**REGULAR MEETING OF THE  
CITY OF CONCORD  
DESIGN REVIEW BOARD**

**REPORT TO DESIGN REVIEW BOARD**

**Project Name:** Chalomar Crossings Subdivision (PL150027-RZ, TM, DR, TR)

**Review Status:** Preliminary Design Review

TRACT 9400  
**PRELIMINARY GRADING, DRAINAGE AND UTILITY PLAN**  
**988 OAK GROVE ROAD**

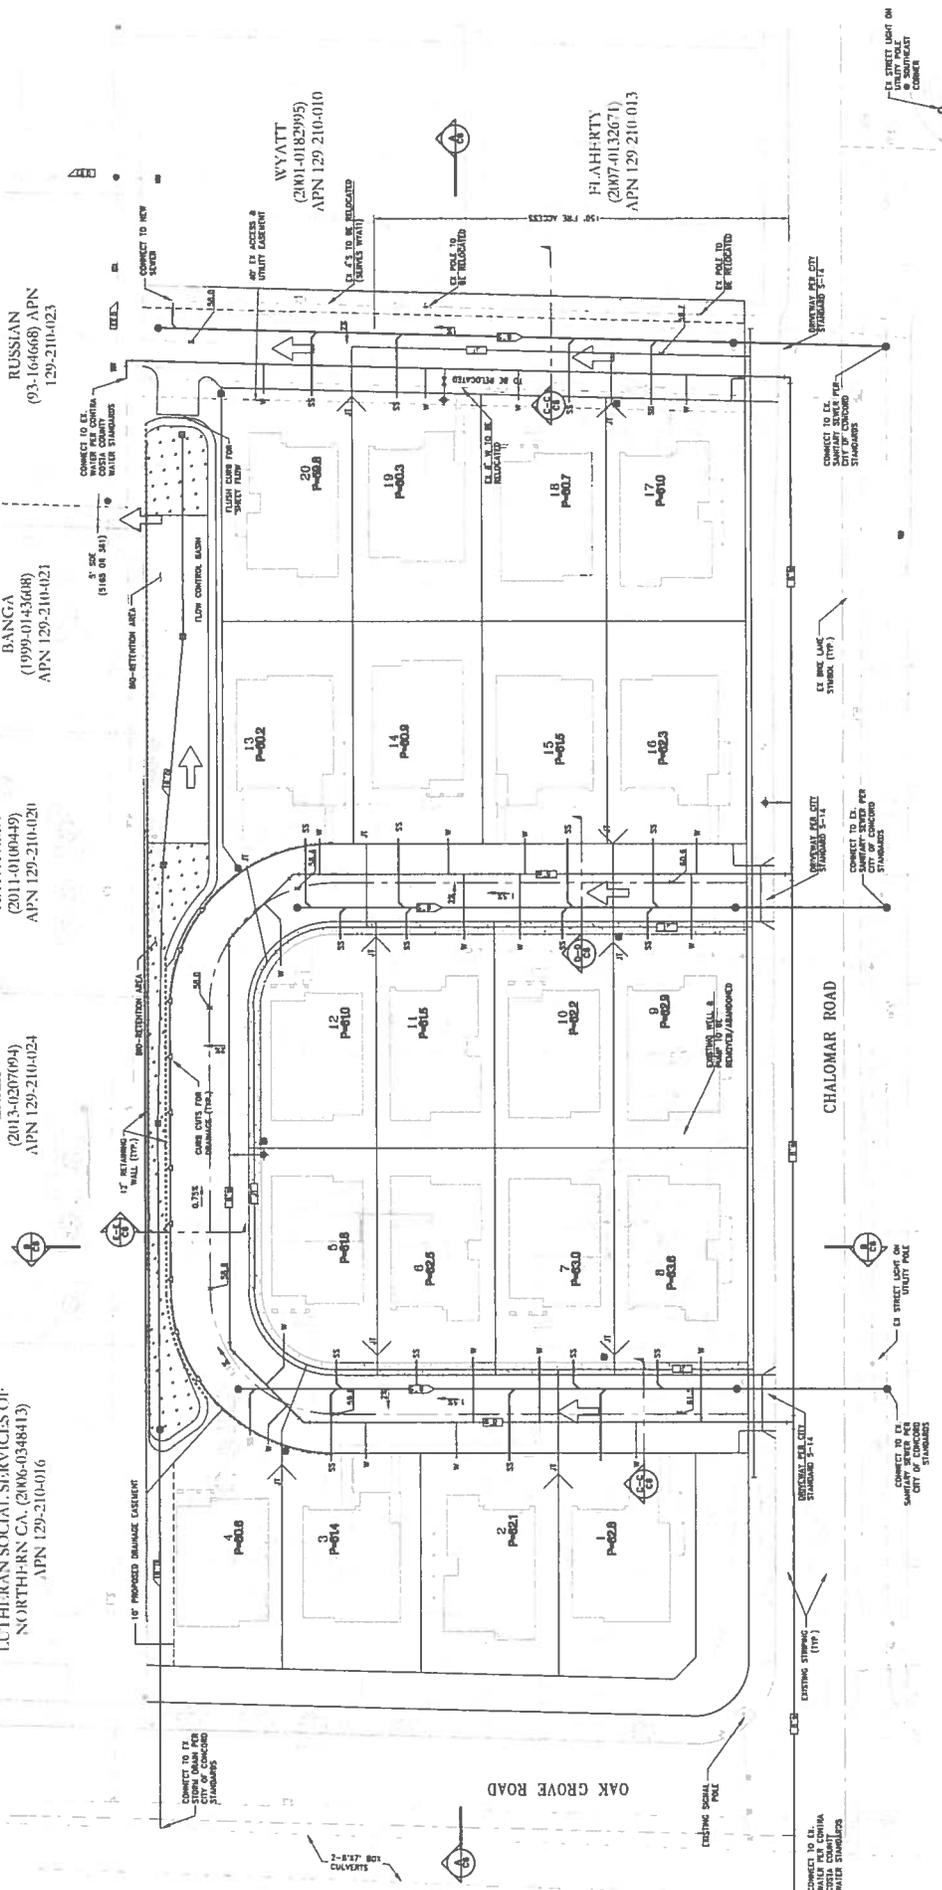
- As shown on the revised project plans, Exhibit B, sheets C4 and C5, storm water requirements are still planned to be accommodated through Parcel B and a new 10-foot wide drainage easement at the northwest corner of the site. The applicant is coordinating with Contra Costa Water District to relocate the waterline further east within the access easement on the east side of the site.

- The plans should be revised to reflect the conclusions of the arborist memo, dated March 27, 2015, which discuss the ability to retain trees #81 to #125 along the northern perimeter of the property (Italian Cypress). The memo indicates that the Italian Cypress trees should not be adversely impacted if the recommendations of the arborist are followed, and would be expected to survive over the long term. Presently, the landscape plans show the removal of trees #97 to #125. Plans should be revised to show these to be retained with recommendations of the arborist incorporated into the project.
- Extend the depth of decorative crosswalks at the private road entry and exists and provide a detail specification. Add decorative hardscaping at the top of the northern end of private roadway across from bioswale and locate consolidated mailboxes at this location.

FARMHOUSE REAR ELEVATION

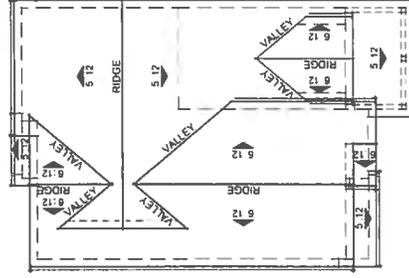
- Although there have been improvements with the addition of roof gables (Plan 1 and 2 Farmhouse rear elevation), the massing of the homes remains generally boxy. The vertical board and batt siding of the farmhouse elevations seems to accentuates the massing. Staff recommends a re-examination of the proportions, perhaps utilizing "soft shoulders" (setting back the second story from the first level), and incorporating a 12" belly band/board to break up the massing of many of the elevations, particularly the Farmhouse style with vertical siding.

- Farmhouse elevations should incorporate greater thickness and dimension to window frames, 12-inch horizontal belly band/board to break up verticality of elevations, window alignment (example Plan 1 rear elevation), and extending board and batt gable detail down from roof.

FARMHOUSE LEFT ELEVATION

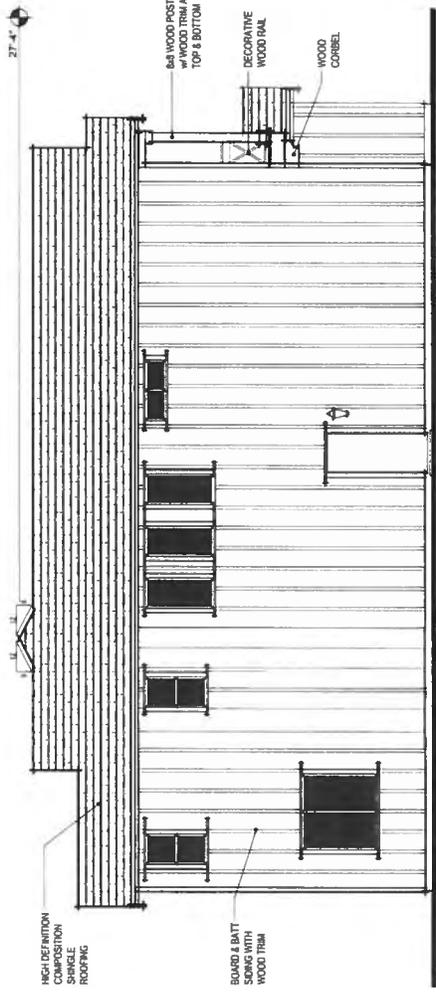
- Additional architectural features such as that shown on the Plan 3 (Farmhouse left elevation), are supported to improve overall appearance from the street view.

PHOTO SIMULATION  
A18

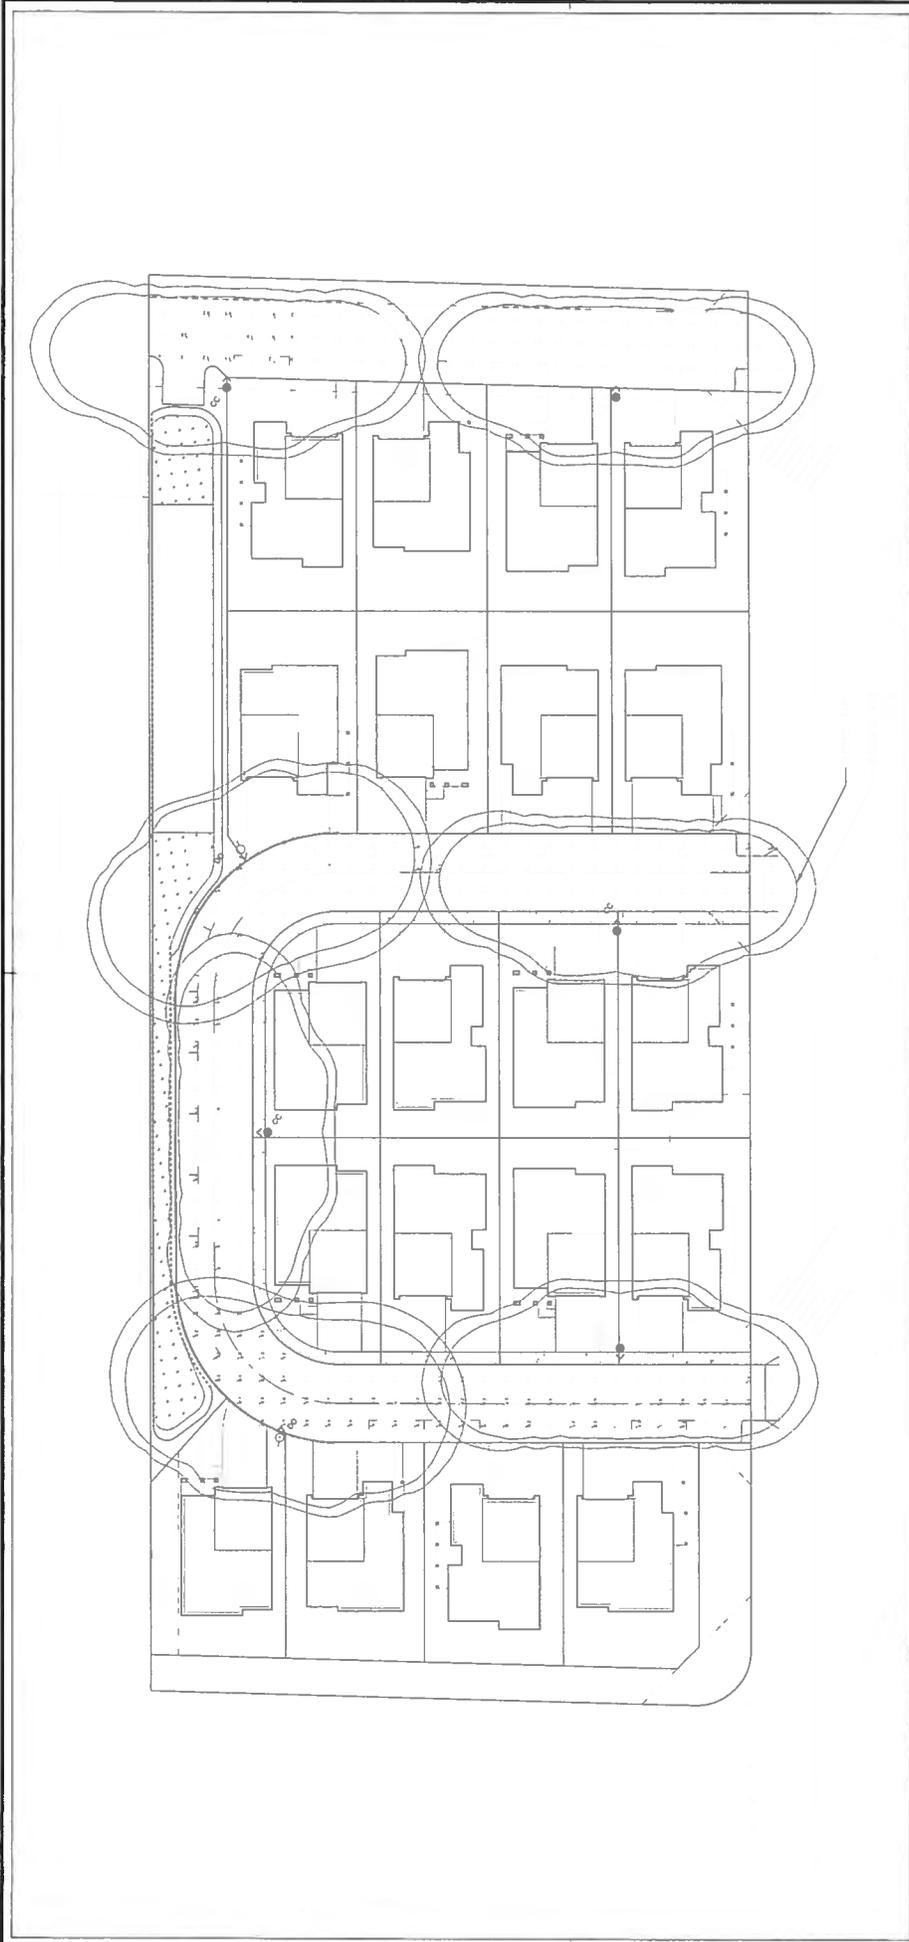
- Plan 1 is provided with Farmhouse and Craftsman architectural style elevations. Plan 2 is provided with Farmhouse and Traditional architectural styles with alternate elevations for corner locations along Chalomar Road. Plan 3 is provided with Farmhouse and Traditional style elevations. The applicant has now provided updated plans shown on Sheet A18 to show the Oak Grove Road streetscape appearance.
